TOLERANCES		WESTERBEKE CORPORATION	
INCHES	MILLIMETERS	AVON MA. 02322	
FRACTIONS		WIRING DIAGRAM / SCHEMATIC	
DECIMALS		3.0KW/3.5KW BCDT ©	
ANGLES		DATE	02/18/91
THROUS		DESIGNED BY	
		DRAWN BY	
		CHECKED BY	
		DATE	
		SCALE	NONE
		SIZE	A
		REV.	44163 G
		DRG. NO.	44163 G

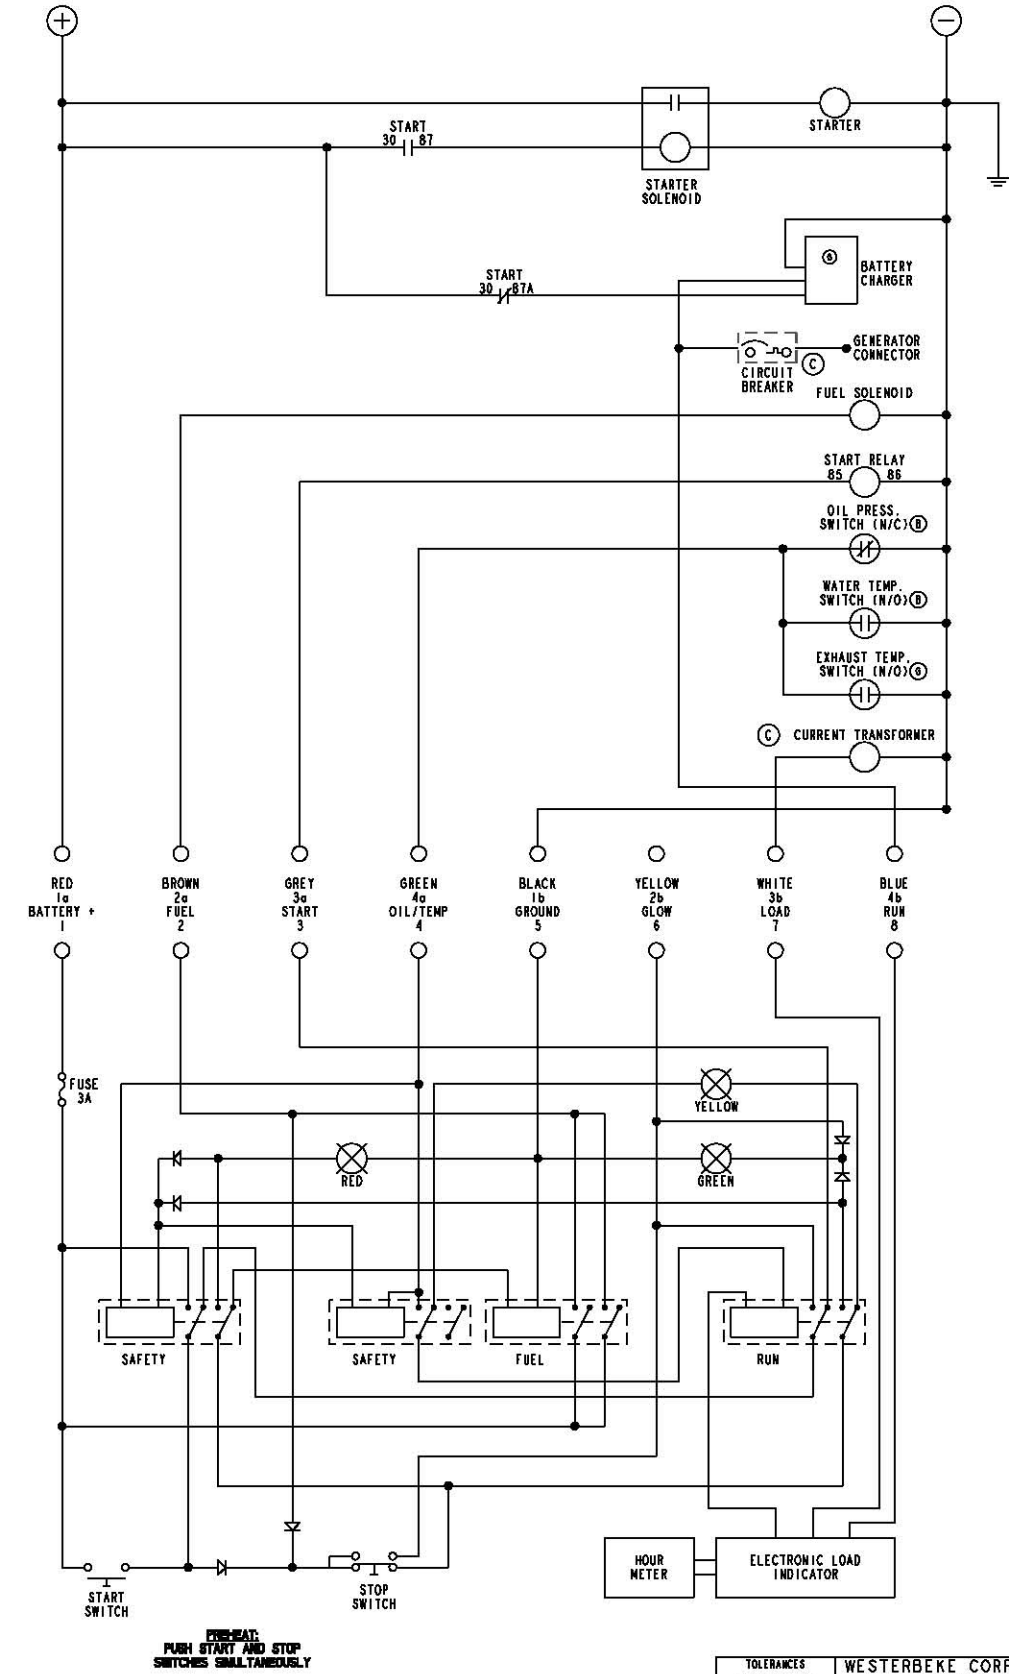
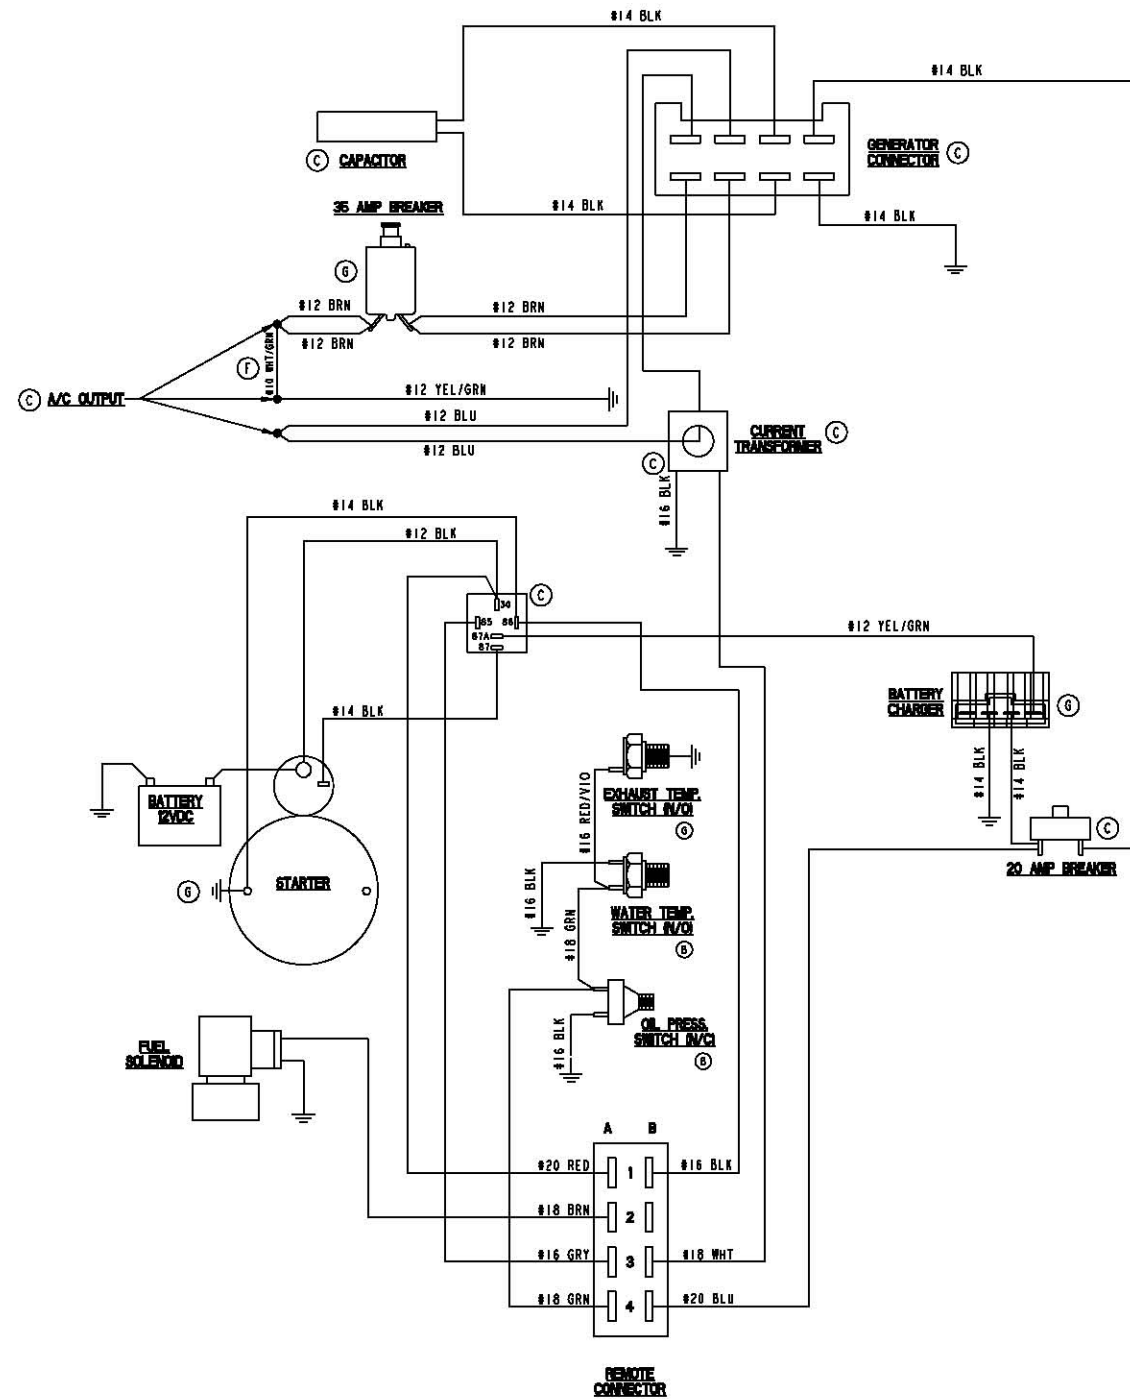
ECO NO.	DATE	REV.	REVISION RECORD	INIT.	DR. BY
4231	1/14	A	D. 47 WAS 47; ADDED GROUND.		CEU
4574	5/24	B	ADDED (N/O) TO WATER TEMP SWITCH ADDED (N/C) TO OIL PRESS. SWITCH		JEC
4743	12/5	C	UPDATED WIRING FOR: BAT. CHARGER RECTIFIER, RELAY, CURRENT TRANS. REMOVED FUSE 2 RESISTOR, CIRCUIT BREAKER, FUSE, CONN., CAP., & AMP. OUTPUT		TSM
4819	2/14	D	CHANGE IN TITLE: 3.0/3.5 FROM 4.2/3.5		LLM
4885	2/19	E	ADDED RESISTOR TO BATTERY CHARGER		JCH
5084	1/1	F	ADDED JUMPER #10 WHITE/GREEN		RM
5187	2/1	G	UPDATED BATTERY CHARGING CIRCUIT ADD EXHAUST TEMP SWITCH & 35A C.B. ADDED GROUND WIRE TO STARTER.		TSM
